EARLY GRADING AND EROSION CONTROL PLANS SPRINGS AT WATERVIEW

EL PASO COUNTY, STATE OF COLORADO

Markup Summary

SHEET TITLE TITLE SHEET

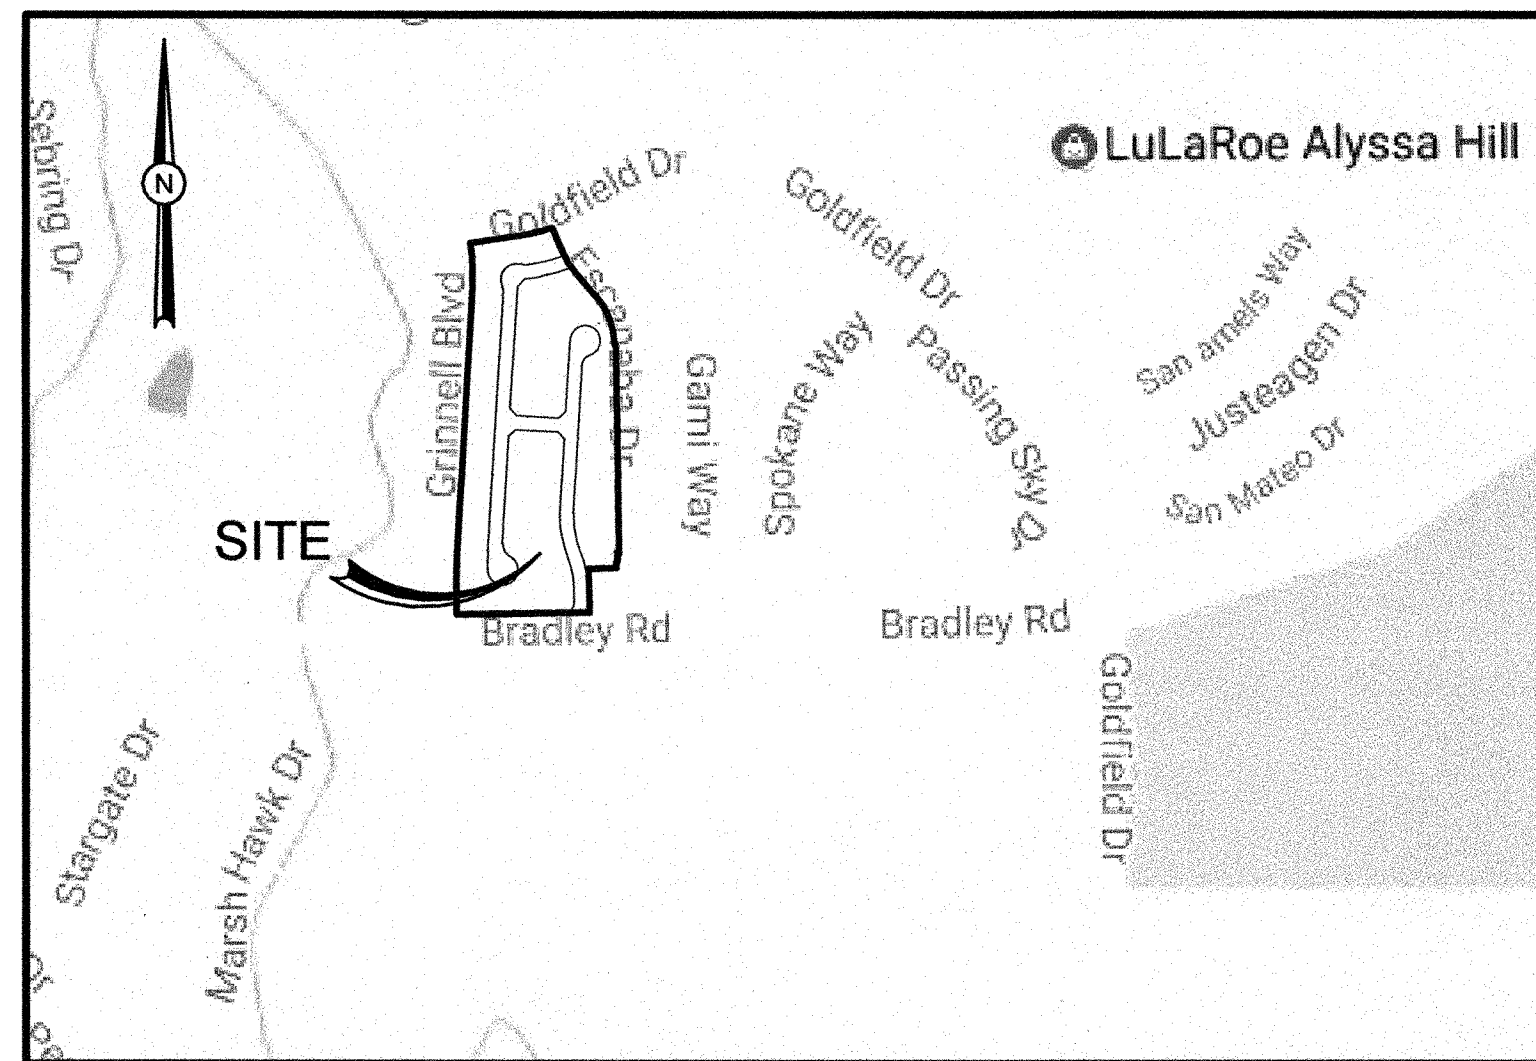
Revise header to "El Paso County"

DSE Dakota Springs Engineering
 PROJECT SPRINGS AT WATERVIEW
 SHEET TITLE GRADING & EROSION CONTROL PLAN
 FROM _____ TO _____
 JOB NO. 0102.1 SHEET 4 OF 6

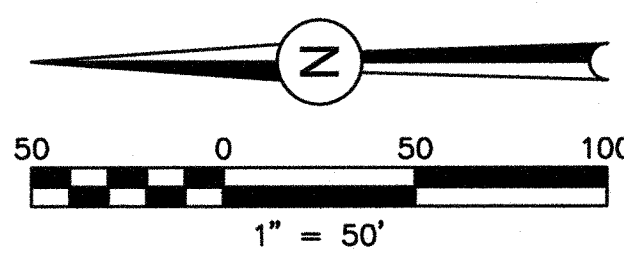
1. Show the actual design contours. Identify the minimum required volume

Identify RCS along these road segments

Add Inlet Protection

Add Inlet Protection
